Melaleuca 1, Thredbo Village Modification

Modification Application Assessment (MOD 23/16950 (DA 9373 MOD 2))

May 2024

Published by the NSW Department of Planning, Housing and Infrastructure

Figure 4 | Proposed modification works: highlighted in red (Source: Applicant's documentation)

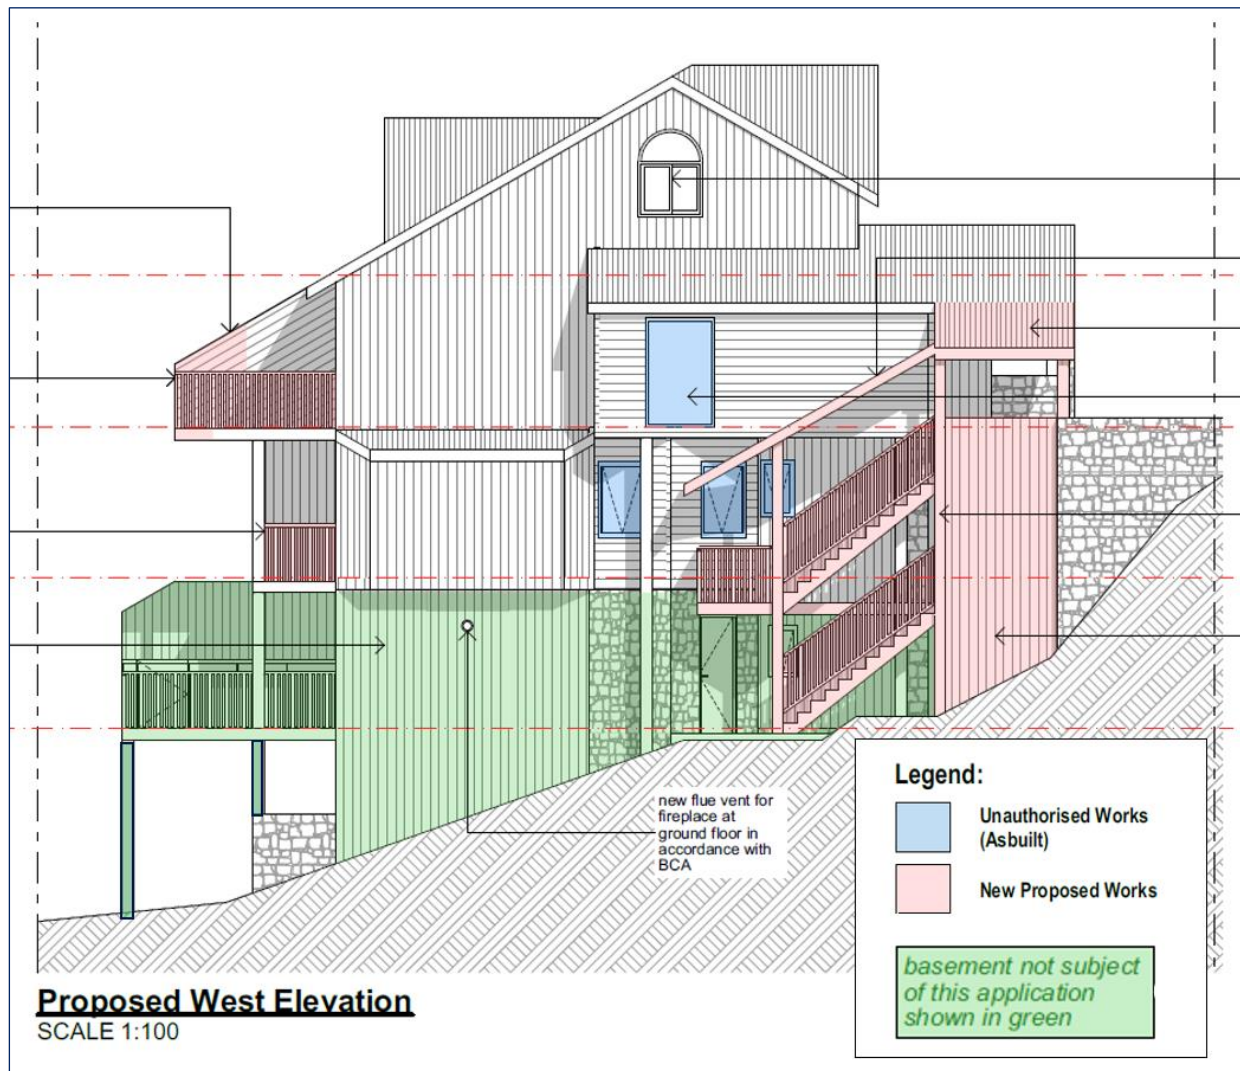
On 18 December 2023, the Applicant lodged a modification application (MOD 23/16950 - DA 9373 MOD 2) seeking approval, under section 4.55(1A) of the EP&A Act, to modify the development consent incorporating internal and external alterations to the above development. The proposed modification works are indicated in red on the submitted architectural plans and are outlined in **Table 2** below:

As discussed in Section 1.3 above, any identified 'As Built' works that have already been constructed (as shown in blue on the architectural plans) do not form part of this modification. Works relating to the basement additions and amendments are also not included as part of this assessment (as shown in green on the Architectural Plans). There would be no increase in the bed capacity or use of the building due to the proposed modifications.

Figure 6 | Proposed external alteration in blue (Source: Annotated over Applicant's documentation)

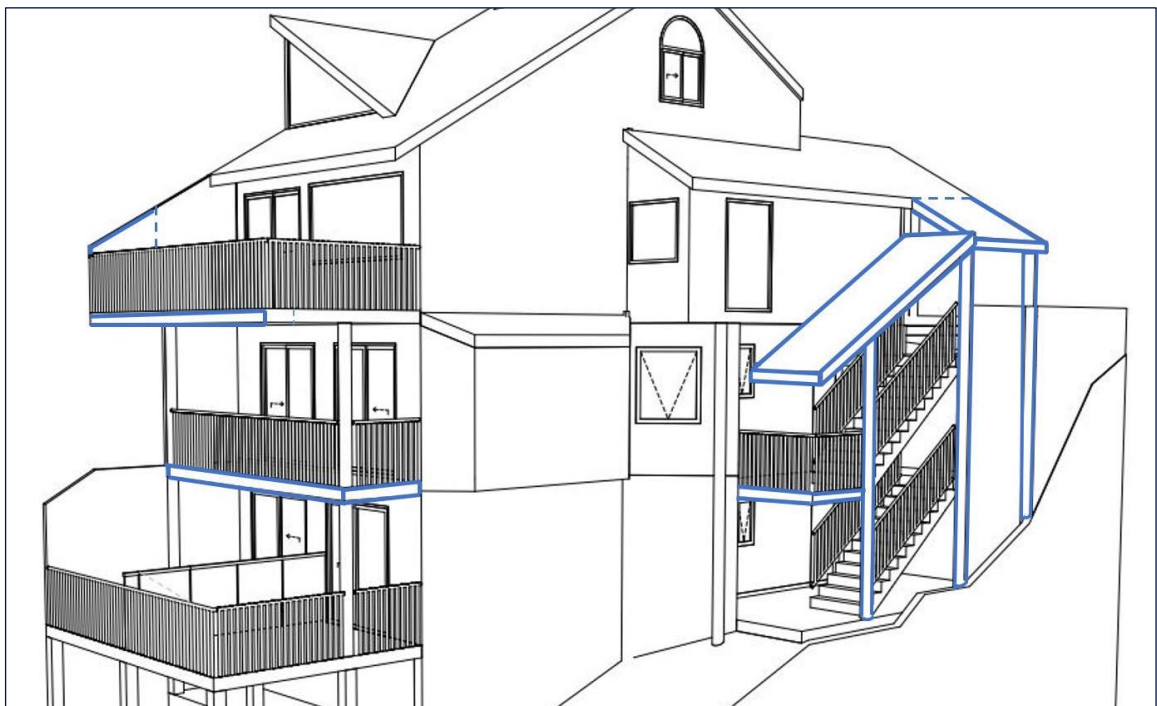
The new external staircase proposal includes a number of design changes as seen in **Figure 6**, including the following:

- Amendment to the design of the external stairs to include two equal flights of stairs each with a length of 2.28m

- An extension of the first-floor landing space connecting each flight of stairs to accommodate a new storage cupboard and service enclosure
- Inclusion of new external staircase supporting steel members, steel beams and handrails.
- Extension of the existing roof rafters and addition of a new sloped roof in colorbond materials to cover the new external stairway.

The Department considers that the external stair design changes are not substantially different to what has already been assessed as part of DA 9373 Mod 1. The steep incline of the roof design accommodates for an improvement in roof coverage and snow loading capacity (**Figure 6**). Additionally, the dual flights of stairs allow for a larger first floor landing space, providing better residential amenity and the provision of a new storage cupboard and service enclosure (**Figure 7**).

Figure 7 | First floor level works (Source: Applicants documentation)

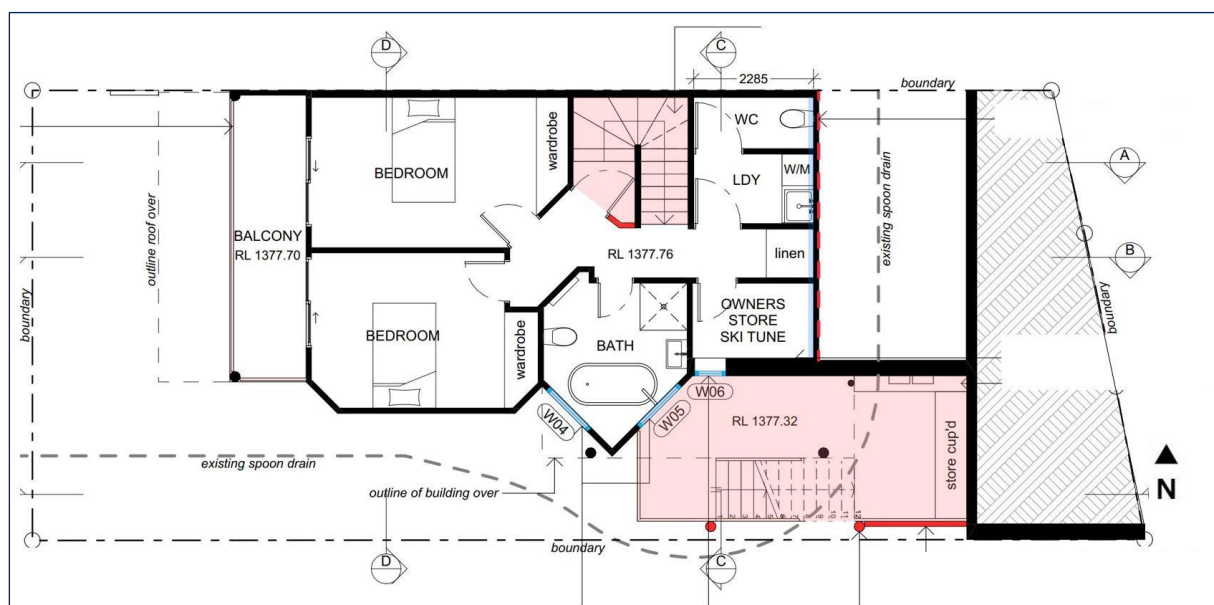
- The extension of the existing deck and privacy screen located on Level 2 (**Figure 8**) including the installation of new timber decking, utilising existing structures without significantly altering the appearance of the building.
- Installation of new timber decking and steel balustrades on the first-floor balcony (**Figure 7**).

Figure 8 | Second floor level works (Source: Applicants Documentation)

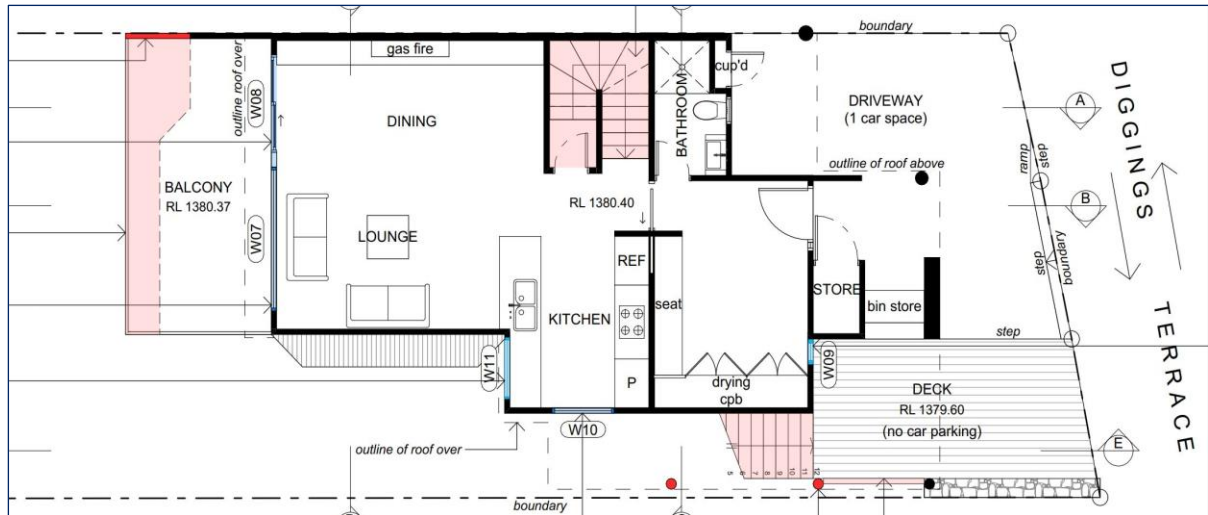
Departments assessment considered that the proposed design changes are unlikely to result in additional impacts to adjoining properties (noting that the adjoining Melaleuca lodge 2 includes a similar extension to the second-floor balcony).
